JOINT REGIONAL PLANNING PANEL (Sydney East Region)

JRPP No	2014SYE143
DA Number	2014/510
Local Government Area	Willoughby City Council
Proposed Development	Demolition of the existing buildings and structures and the construction of three commercial premises and 104 shop-top housing units.
Street Address	150 MOWBRAY ROAD & 670-680 WILLOUGHBY ROAD, WILLOUGHBY NSW 2068
Applicant/Owner	CEEROSE P/L
Number of Submissions	5
Regional Development Criteria (Schedule 4A of the Act)	Capital Investment Value exceeding \$20 Million
List of All Relevant s79C(1)(a) Matters	<ul style="list-style-type: none"> • Willoughby Local Environmental Plan 2012 • State Environmental Planning Policy No 65 – Design Quality of Residential Flat Development • State Environmental Planning Policy (Basix) • State Environmental Planning Policy 55 – Remediation of Land • State Environmental Planning Policy (Infrastructure) • Willoughby Development Control Plan • Exhibited Draft Amendments to WLEP 2012 (House Keeping amendments only) • Draft/ Amended SEPP 65 and Apartment Design Guide

150 Mowbray Road & 670-680 Willoughby Road, WILLOUGHBY NSW 2068

PROPOSAL: DEMOLITION AND CONSTRUCTION OF SHOP TOP HOUSING UNITS, CARPA

Figure 1 (Clause 4.6 Height of Building)

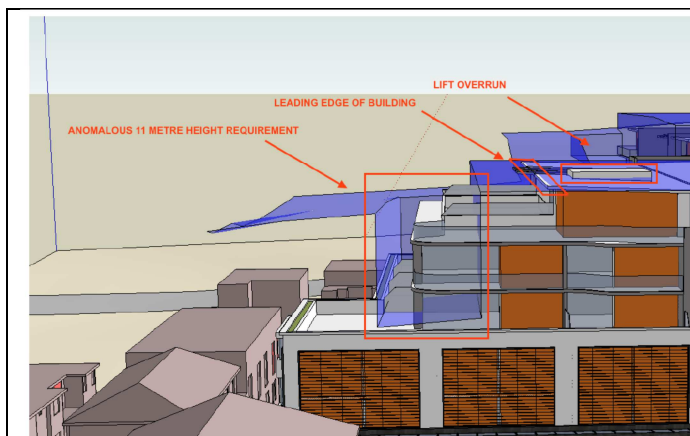
The 2.84 metre breach of the 18 metre height limit at the top of the parapet wall at the north-western corner of Building B is a result of the irregular height plane that is applicable to the site, owing to excavation associated with existing site improvements. **Figures 3 & 4** on the previous pages illustrate the level of excavation associated with the existing building where proposed Building B is to be sited. The basement levels illustrated are properly defined as 'ground level (existing)', despite clearly being excavated levels. The ground level (existing) is reflected in the building height plane illustrated by the architect in the SketchUp model extracts presented at **Figures 1 & 2**. The highly modulated building form that would result from strict adherence to the height of building standard per the LEP definition is not therefore considered to be reasonable in these circumstances.

Where the proposal exceeds the 18 metre height standard, the effect on the overall bulk and scale of the building is negligible. The breach of building height (excepting the lift overrun) can be attributed to the building height definition and the irregular site topography resulting from previous landform modification, rather than from any building element that would offend the objectives of the zone or the development standard. Further, the minimal exceedances of the 18 metre height limit will not contribute to excess bulk when viewed from any public place. Strict application of the standard is therefore considered unnecessary in the circumstances.

Figure 1, & 2 contained in the submitted Clause 4.6 request seeking variation to the height standard is included below.

Figure 3 - Excerpt of submitted drawing A.150 C (red dotted line identifying the irregular reduction in the height standard applying across that part of the site's frontage along Willoughby Road at No 670)

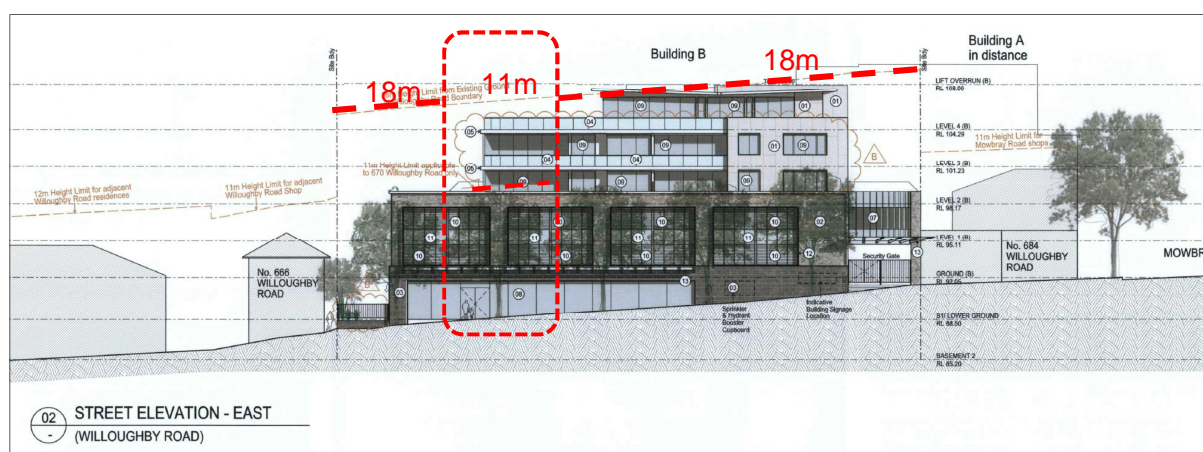
- c. The 11m height standard applying to that part of the site, being No 670 Willoughby Road Willoughby is considered an anomaly. Despite having the same Floor Space Ratio standard representing the development potential of the land, the applicable height control differs between 680 Willoughby Road (18m) and 670 Willoughby Road (11m). Based on the site area and dimensions of the property at No 670 Willoughby Road, and its relationship with the property at No 680 Willoughby Road, strict compliance with the maximum 11m height standard applying to No 670 will not achieve an acceptable built form or development outcomes that are compatible with the streetscape nor will it achieve a suitable transition of building height along Willoughby Road.

Figure 4 - Roof Plan (Amended) Setbacks

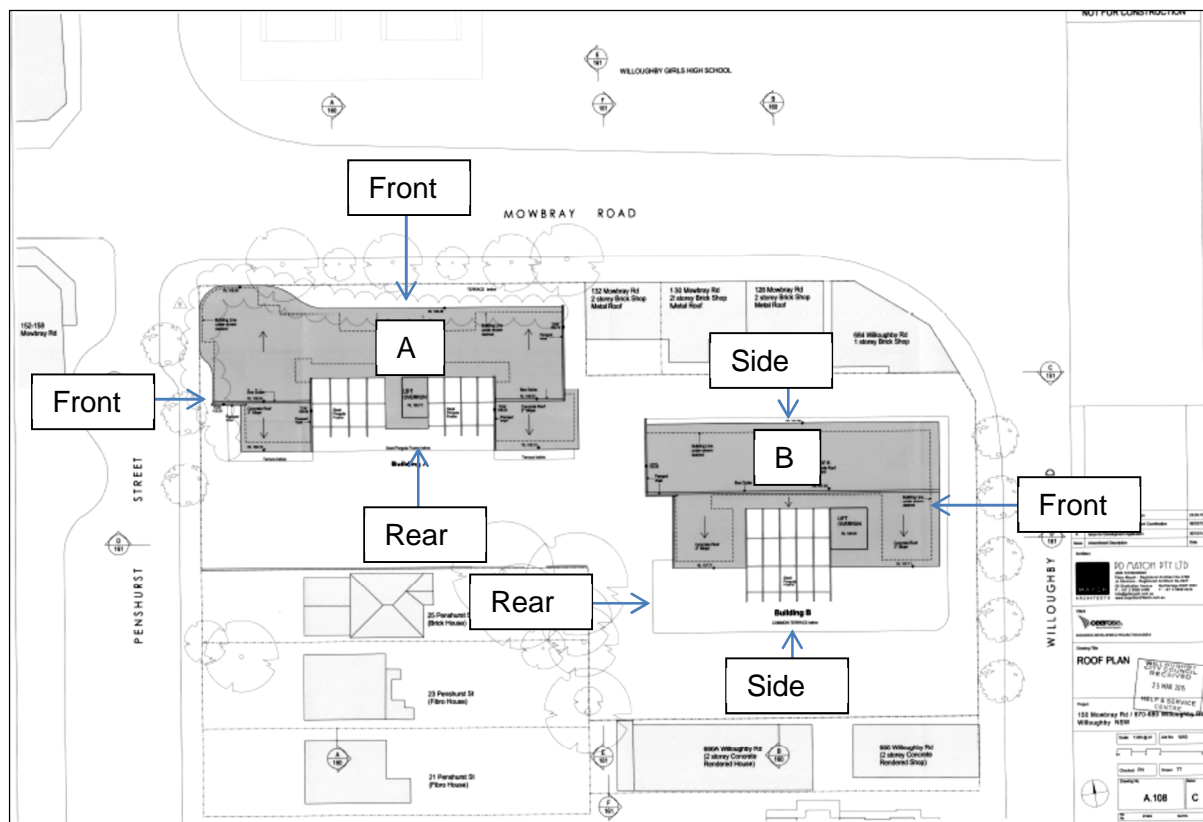
Building A is considered as a corner site/ building at a gateway location at the intersection of Mowbray Road and Penshurst Street, and Building B has its primary frontage on Willoughby Road and backs onto the rear of residential zoned land. The application of setback requirements contained in the WDCP for the proposed buildings as nominated in the Development Statistic is illustrated below.

As noted in the Development statistics, the proposed development does not strictly comply with the required setbacks. However, the assessing officer as well as Council's Urban Consultant agree that the strict application of the setback requirements contained in the WDCP is unlikely to achieve the best planning and development outcomes particularly with respect to the commercial streetscape, and that the proposed setbacks should be considered on the merits of the proposal. As previously discussed in this report, the amended proposal has increased the upper level setbacks from the respective street boundaries, and is considered to achieve an acceptable outcome in terms of streetscape and building appearance.
